**MONTGOMERY COUNTY HISTORIC PRESERVATION COMMISSION**  
**STAFF REPORT**

<b>Address:</b>	10 Newlands Street, Chevy Chase	<b>Meeting Date:</b>	12/19/07
<b>Resource:</b>	Contributing Resource Chevy Chase Village Historic District	<b>Report Date:</b>	12/12/07
<b>Applicant:</b>	Mr. and Mrs. Edward Symes III (Outerbridge Horsey, Architect)	<b>Public Notice:</b>	12/05/07
<b>Review:</b>	HAWP	<b>Tax Credit:</b>	None
<b>Case Number:</b>	35/13-07LL	<b>Staff:</b>	Anne Fothergill
<b>Proposal:</b>	Rear addition and alterations to house

TO: Anne Fothergill, Montgomery County Historic Preservation  
FROM: Outerbridge Horsey, AIA  
DATE: December 11, 2007  
RE: 10 Newlands, Chevy Chase Village  
BY: Email

SUBJECT: Historic Area Work Permit #470873 – Rear addition and alterations to house

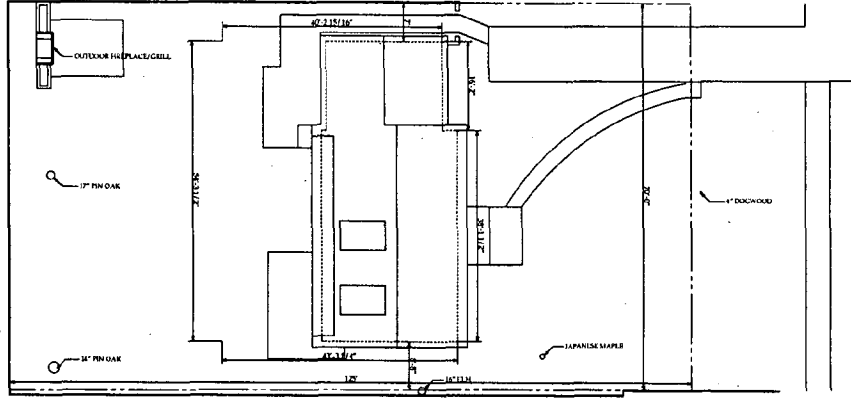
We have also modified an existing window on the front elevation of the west wing of the house, which is a 1950's addition. The window is currently configured as three casement windows with transoms. There are no casement windows in the original part of the house. The proposed window is configured as a double hung window with smaller double hung flankers.

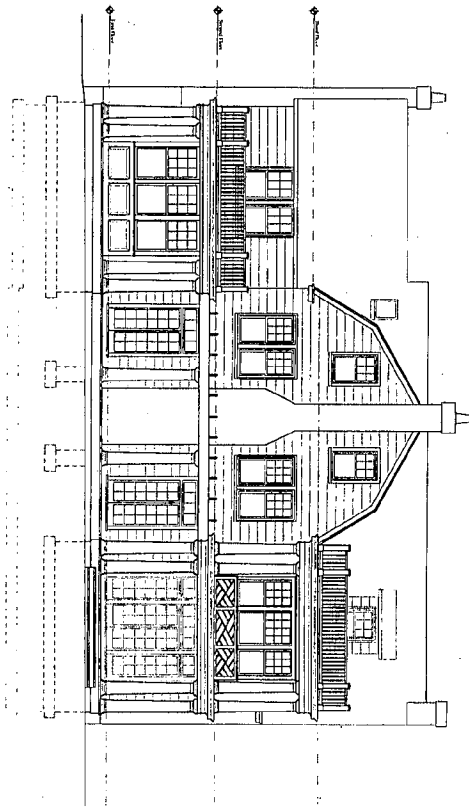
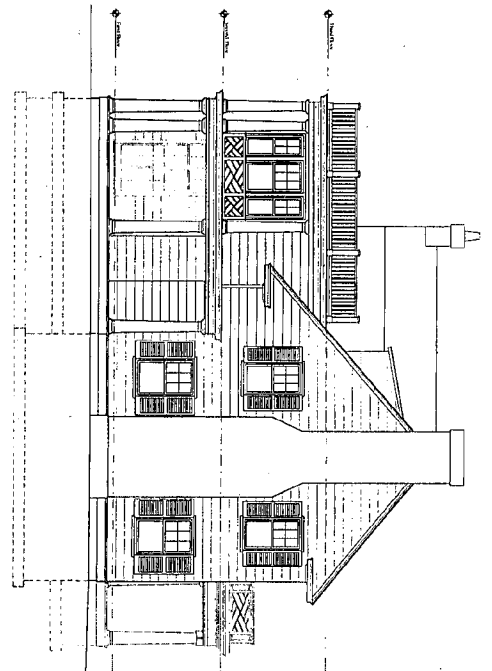
Staff encouraged the design team to explore a revised design on the side elevations, which maintains the gable ends in their entirety. This is the modified plan shown on circle 13. Staff prefers these elevations as it retains the catslide detail on the side elevations.
